Access Compliance Report

Public Rights-of-Way

(Curb Ramps)

Intersection ID: 12240	Main Street: ALLEN_ST	Cross Street: E_15TH_ST	Location: S
ADA ID: C455EF93D227	Ramp Type: BlendTrans1	Initial Pass/Fail: Fail	Overall Compliance: No
		Severity Score: 8.75

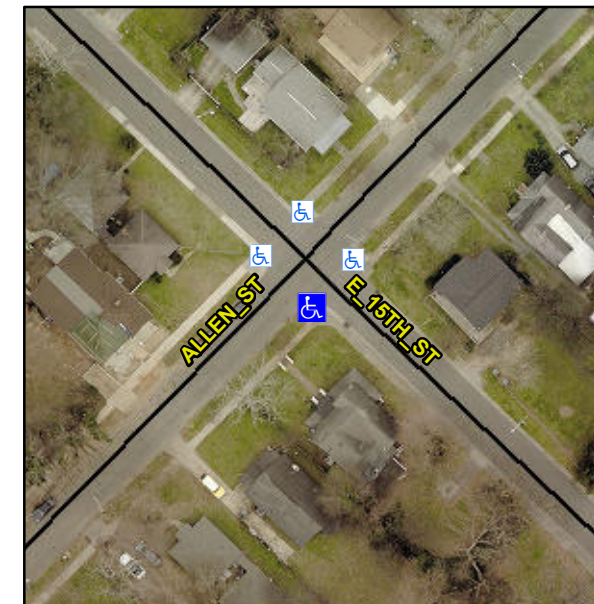
Not Found, R304.5.1

Compliance	Description	Data	Compliance	Description	Data
N/A	Ramp Length (in)	65.0	Yes	BlendTrans Slope (%)	4.3
No	Ramp Width (in)	42.0	Yes	BlendTrans XSlope (%)	0.8
N/A	Flare Type LT	N/A	N/A	Flare Type RT	N/A
N/A	Flare Slope LT (%)	N/A	N/A	Flare Slope RT (%)	N/A
N/A	Flare Traversable LT?	N/A	N/A	Flare Traversable RT?	N/A
N/A	Landing Length (in)	N/A	N/A	DWS Provided?	N/A
N/A	Landing Width (in)	N/A	N/A	DWS Contrast?	N/A
N/A	Landing Slope (%)	N/A	N/A	DWS Length (in)	N/A
N/A	Landing X Slope (%)	N/A	N/A	DWS Full Width?	N/A
N/A	Landing Curb? (Y/N)	N/A	N/A	DWS Offset (in)	N/A
N/A	Shared Landing?	N/A			
N/A	Gutter Ponding?	N/A	N/A	Gutter Slope (%)	N/A
N/A	Gutter Lip Ht (in)	N/A	N/A	Gutter X Slope (%)	N/A
N/A	Painted X Walk1?	No	N/A	Painted X Walk2?	No
	X Walk 1 Direction	To NE		X Walk 2 Direction	To NW
	X Walk 1 Width (in)	N/A		X Walk 2 Width (in)	N/A
	X Walk 1 Slope (%)	3.7		X Walk 2 Slope (%)	2.2
	X Walk 1 X Slope (%)	2.7		X Walk 2 X Slope (%)	2.0

N/A	Ramp inside XWalk1?	N/A	N/A	Ramp inside XWalk2?	N/A
	Road Slope (%)	5.7		Clear Space?	N/A
	Road X Slope (%)	3.7	N/A	Clear Space to XWalk (in)	N/A
N/A	Any Obstructions?	N/A	N/A	Storm Grate/Utility Hazard?	N/A
	Obstruction Type			Storm Grate/Utility Type	
		N/A			N/A
			Yes	Surface Condition? (G/P)	Good
			No	Curb Slope (%)	19.1

Remove & Replace Curb Ramp With Two New Directional Ramps or Equivalent.
